## Belmont Skating Rink

Schematic Design

October 3rd, 2022

## Reduced Option Value Engineering Deductions

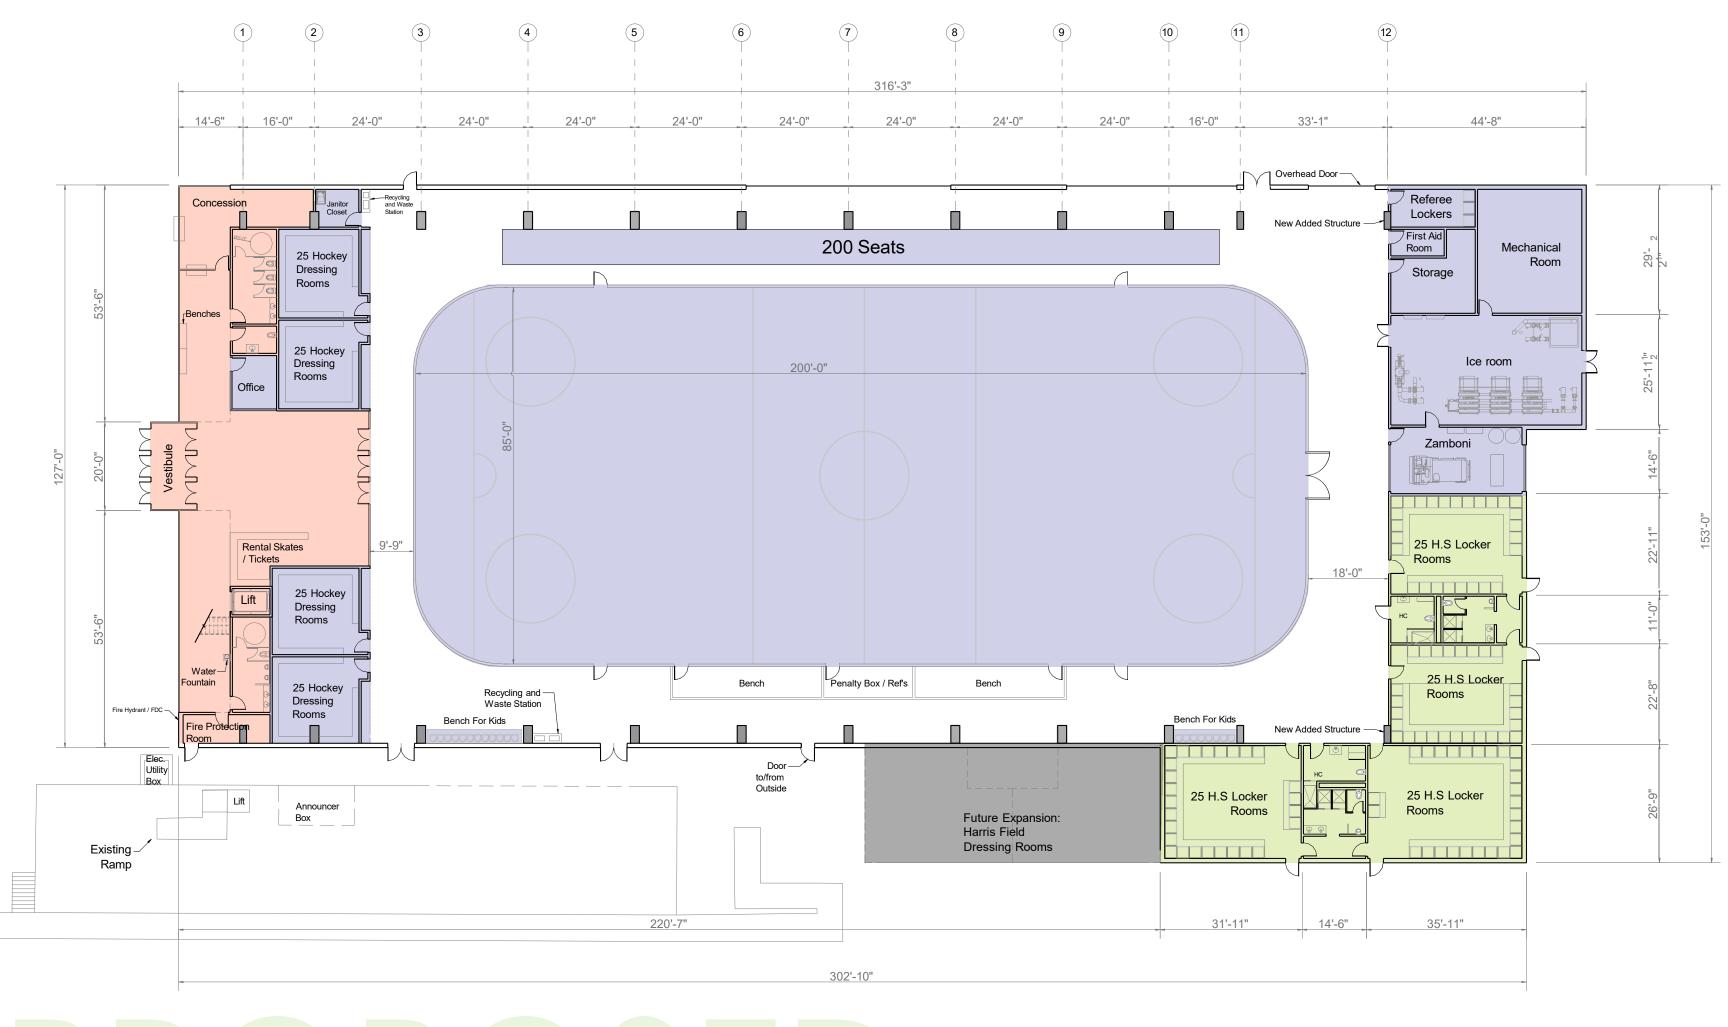
Eliminate 2 Harris Field locker rooms (2,316 sf)

Eliminate DPW Shop (993 sf)

Proposed (41,465 sf) VS Previous (48,800 sf)

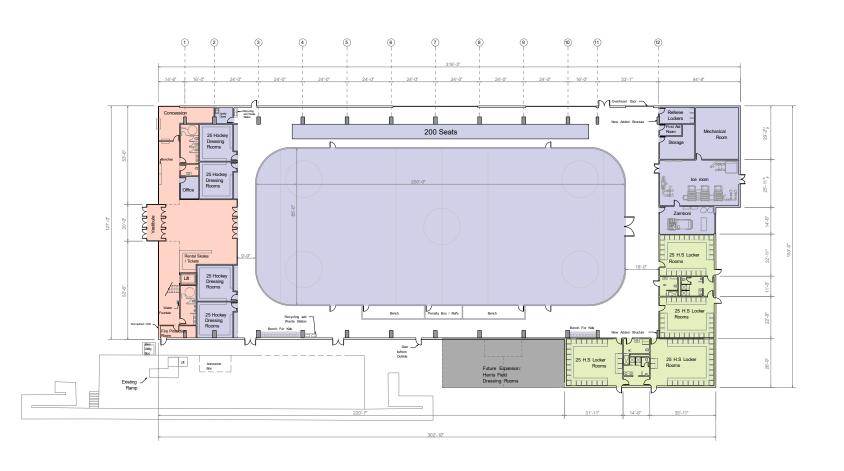
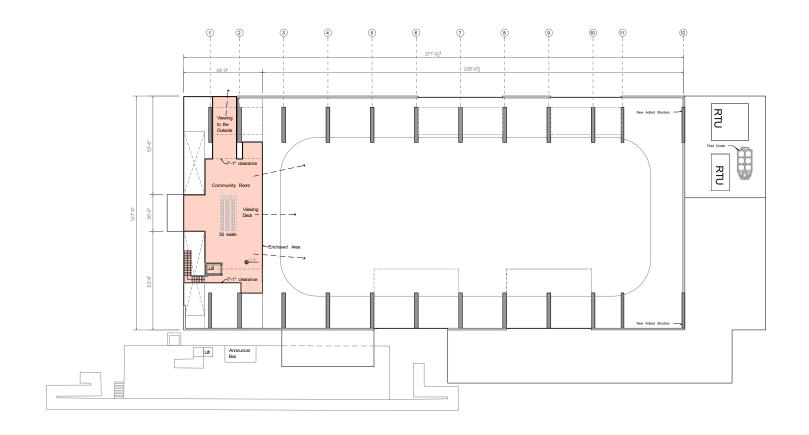
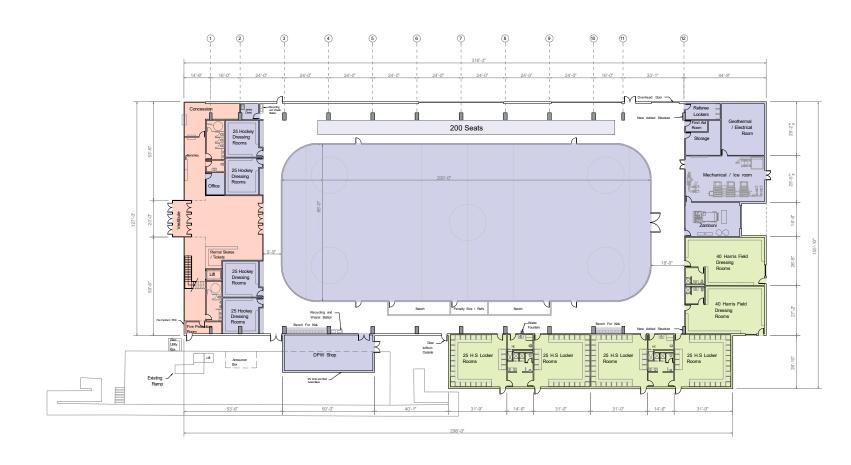
Scale Back Rink Entrance Mezzanine (2,919 sf)

Eliminate White Field House Demolition

Reduce scale for parking and entrance plaza
